Subject: DA2021 1408 - 16 Addison Rd, Manly - Objection

RE: DA2021/1408 – 16 ADDISON RD, MANLY – NEW DWELLING - OBJECTION.

We have been engaged, in a town planning advisory capacity, by the owners of 14 Addison Road, Manly, located to the immediate south-west of the development site.

Figure 2: Extract proposed Ground Floor Plan

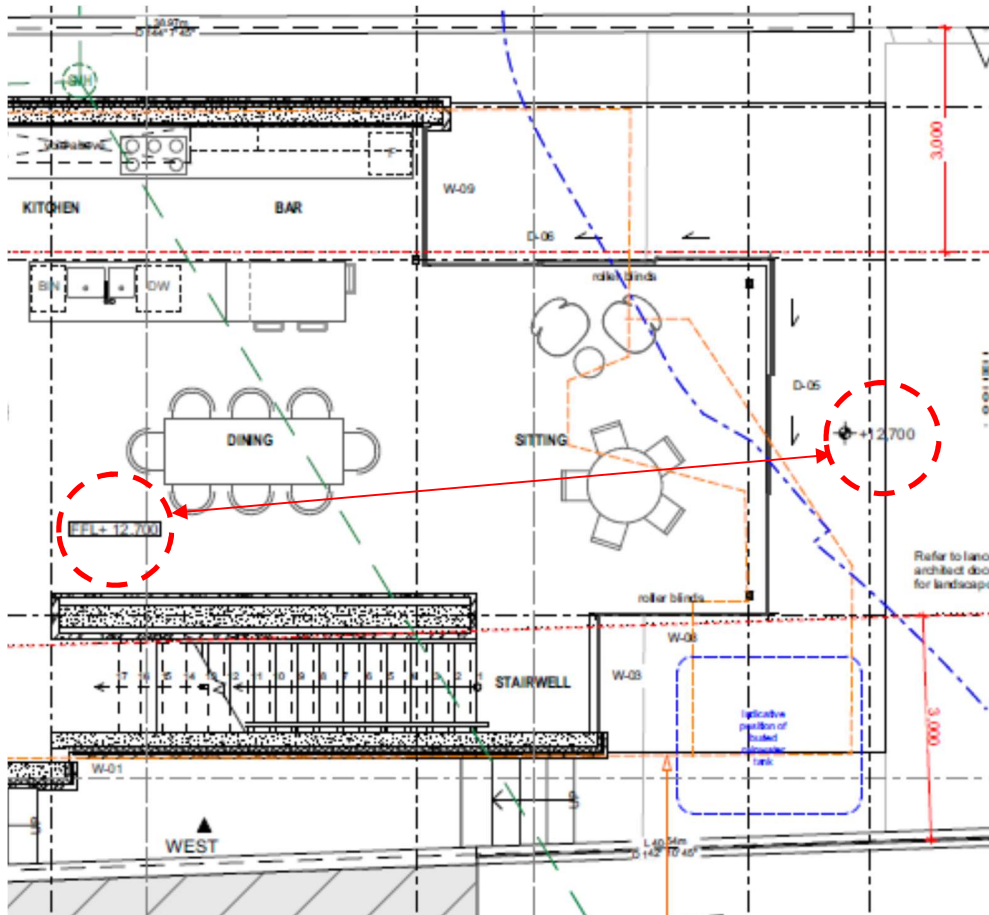
We also bring to the attention of Council an annotation on the proposed Ground Floor Plan which is either incorrect or misleading. Refer to Figure 2 below.

The proposed ground floor plan shows a floor level within the building of RL12.7 and another level to the east of the building footprint of RL12.7. This indicates that the floor level extends to the east beyond the Sitting Room but no balcony is proposed. This anomaly needs to be corrected to ensure the plans are consistent with the elevations and the annotation is not used to support the construction of a balcony which does not appear on the elevations and sections.

Figure 5: Relationship between glazed façade and neighbouring windows. Source: Patterson Architects

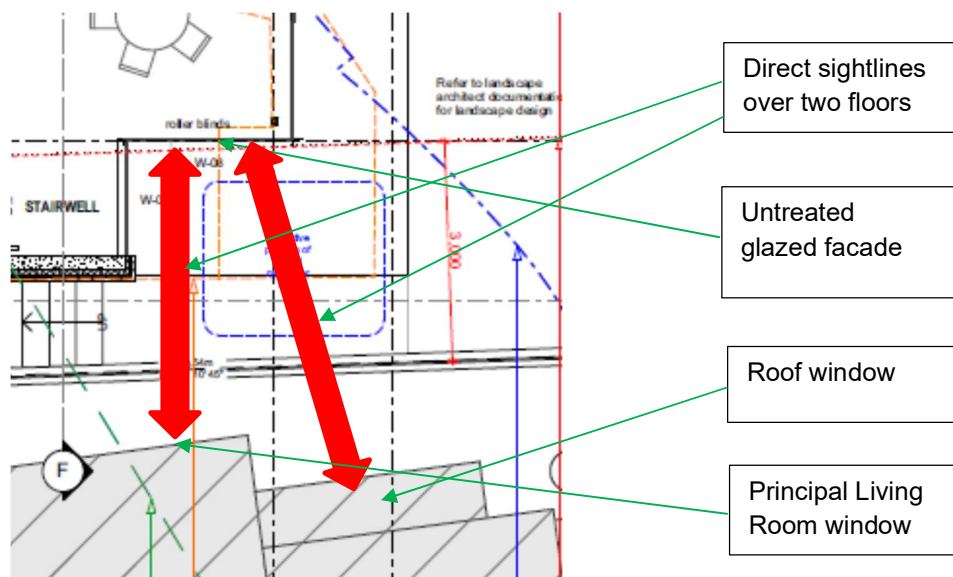
The principal living room at 14 Addison Road has a glazed roof window/skylight in proximity to the boundary interface of 14 Addison Road and the development site. Refer to Figures 4 and 5 below.

Due to the facades of the rear portion of the proposal being comprised entirely of glazing there will be direct, unscreened sightlines between the proposed master bedroom and living room and the principal living space, and family room within 14 Addison Road – an unacceptable outcome for both parties.

The distance between the proposed glazed façade and the affected windows at 14 Addison Road is ~5m which is not adequate.

Figure 6: Extract Wall Height Compliance Diagram Source: Paterson Architects

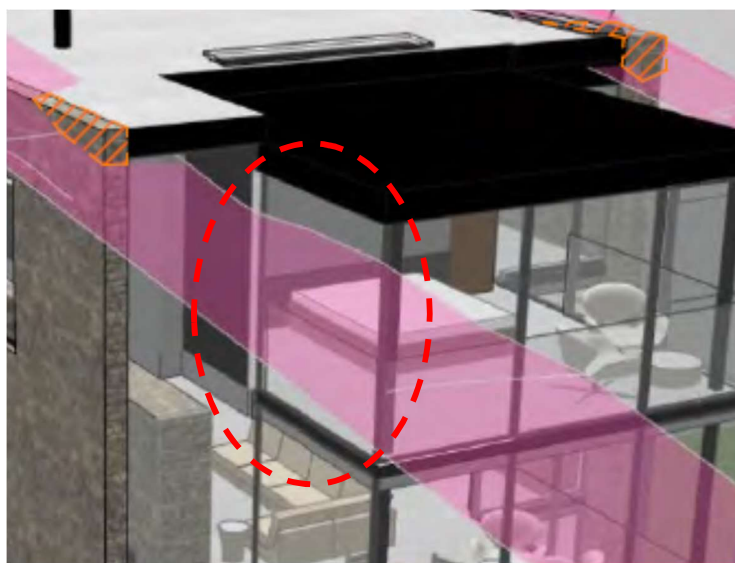
The proposed breach to the wall height control contributes to the significant privacy related impacts. As shown in Figure 6 below, the glazed room (master bedroom) on the first floor at the rear sits almost entirely above the 7.2m wall height control.

This glazed element is almost entirely beyond the wall height control and is considered to be unacceptable and incapable of justification on a merit's basis given it a significant source of overlooking. Refer to Figure 4 above)

Figure 7: Extract West Elevation

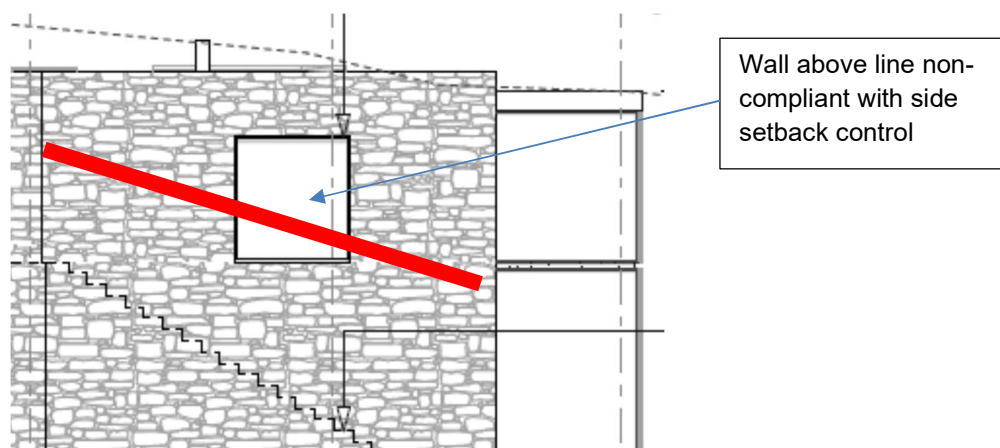
There are windows on both side elevations which are located above the maximum wall height control. The window on the west elevation is deemed to be satisfactory in the submitted SEE since it is located at a relatively higher level than the stairs directly below. Refer to Figure 7 below.

Figure 8: Extract First Floor Plan

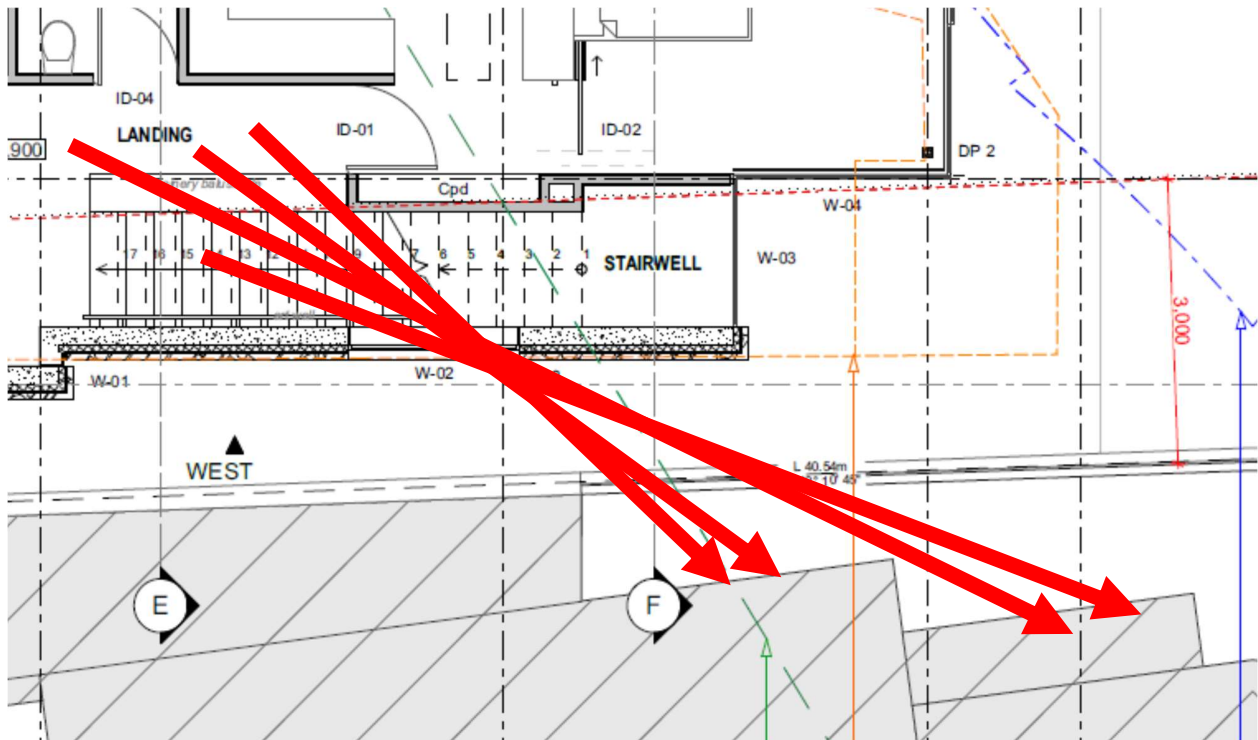
The siting of the window at a relatively high position above the stair below does not satisfactorily mitigate privacy impacts since there will be direct sightlines from higher level stairs and the first-floor level to the windows leading to the primary living space and family room at 14 Addison Road. Refer to Figure 8 below.

Since window (W-02) is a source of privacy impact and it does not comply with the side setback control, it is considered to be unacceptable and incapable of justification on a merit's basis.
